1984 Corvette: Campaign: Power Steering Pump Pulley Failure

Number: 84C03

Subject: P/S Pump Pulley Failure

TO: ALL CHEVROLET DEALERS

DISCONTINUED VS. REVISED PULLEY

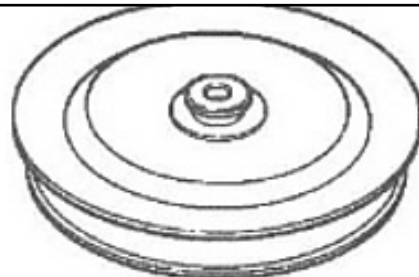
General Motors has determined that certain 1984 Chevrolet Corvettes are equipped with power steering pump pulleys which may crack at the outer edge. Continued operation may cause the pulley to break, resulting in loss of the drive belt. If the pulley cracks, vehicle occupants should be alerted by a rattling sound coming from the engine compartment.

DISCONTINUED
PULLEY

REVISED PULLEY

To prevent the possibility of this condition occurring, it will be necessary to install a new power steering pump pulley on all involved vehicles in accordance with the instructions outlined in this bulletin.

Power steering pump pulley, P/N 14055114, required to complete this campaign will be shipped directly to the dealers' Service Manager from Chevrolet Central Office. Parts quantities will be determined by the number of vehicles identified on the computer list furnished each involved dealer with the campaign bulletin. Dealers are to install these pulleys only on vehicles within the parameters outlined in this bulletin.
